Access Compliance Report

Public Rights-of-Way

(Curb Ramps)

Intersection ID: 52174	Main Street: BRITTON_DR	Cross Street: AVERY_MEADOWS_DR	Location: SW
ADA ID: 03C83ADDF0D4	Ramp Type: PerpDiag	Initial Pass/Fail: Fail	Overall Compliance: No
Severity Score: 21.25			
Codes/Mitigation Info/Possible Solution		Field Measurements/Component Compliance

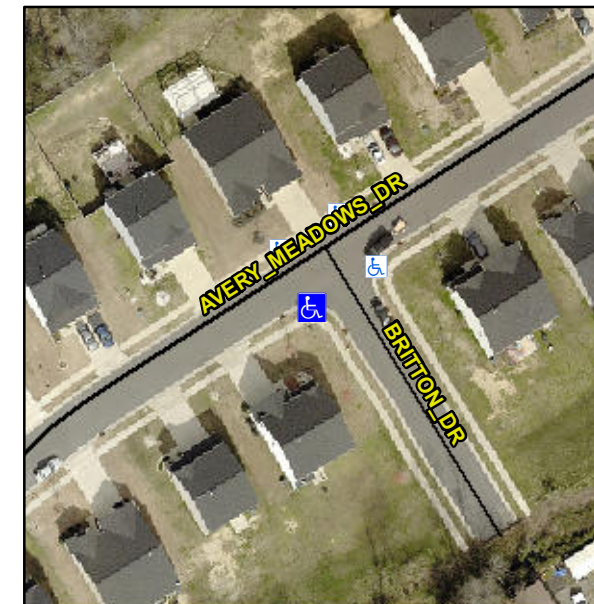
Not Found, R304.5.1, R304.5.3

Compliance	Description	Data	Compliance	Description	Data
N/A	Ramp Length (in)	46.0	Yes	Ramp Slope (%)	5.6
No	Ramp Width (in)	47.5	No	Ramp XSlope (%)	6.2
N/A	Flare Type LT	N/A	N/A	Flare Type RT	N/A
N/A	Flare Slope LT (%)	N/A	N/A	Flare Slope RT (%)	N/A
N/A	Flare Traversable LT?	N/A	N/A	Flare Traversable RT?	N/A
N/A	Landing Length (in)	N/A	N/A	DWS Provided?	N/A
N/A	Landing Width (in)	N/A	N/A	DWS Contrast?	N/A
N/A	Landing Slope (%)	N/A	N/A	DWS Length (in)	N/A
N/A	Landing X Slope (%)	N/A	N/A	DWS Full Width?	N/A
N/A	Landing Curb? (Y/N)	N/A	N/A	DWS Offset (in)	N/A
N/A	Shared Landing?	N/A			
N/A	Gutter Ponding?	N/A	N/A	Gutter Slope (%)	N/A
N/A	Gutter Lip Ht (in)	N/A	N/A	Gutter X Slope (%)	N/A
N/A	Painted X Walk1?	No	N/A	Painted X Walk2?	No
	X Walk 1 Direction	To E		X Walk 2 Direction	To N
N/A	X Walk 1 Width (in)	N/A	N/A	X Walk 2 Width (in)	N/A
	X Walk 1 Slope (%)	5.7		X Walk 2 Slope (%)	0.6
	X Walk 1 X Slope (%)	3.9		X Walk 2 X Slope (%)	5.6

N/A	Ramp inside XWalk1?	N/A	N/A	Ramp inside XWalk2?	N/A
	Road Slope (%)	2.0	N/A	Clear Space?	N/A
	Road X Slope (%)	5.9	N/A	Clear Space to XWalk (in)	N/A
N/A	Any Obstructions?	N/A	N/A	Storm Grate/Utility Hazard?	N/A
	Obstruction Type			Storm Grate/Utility Type	
		N/A			N/A
			Yes	Surface Condition? (G/P)	Good

Remove & Replace Curb Ramp With Two New Directional Ramps or Equivalent.
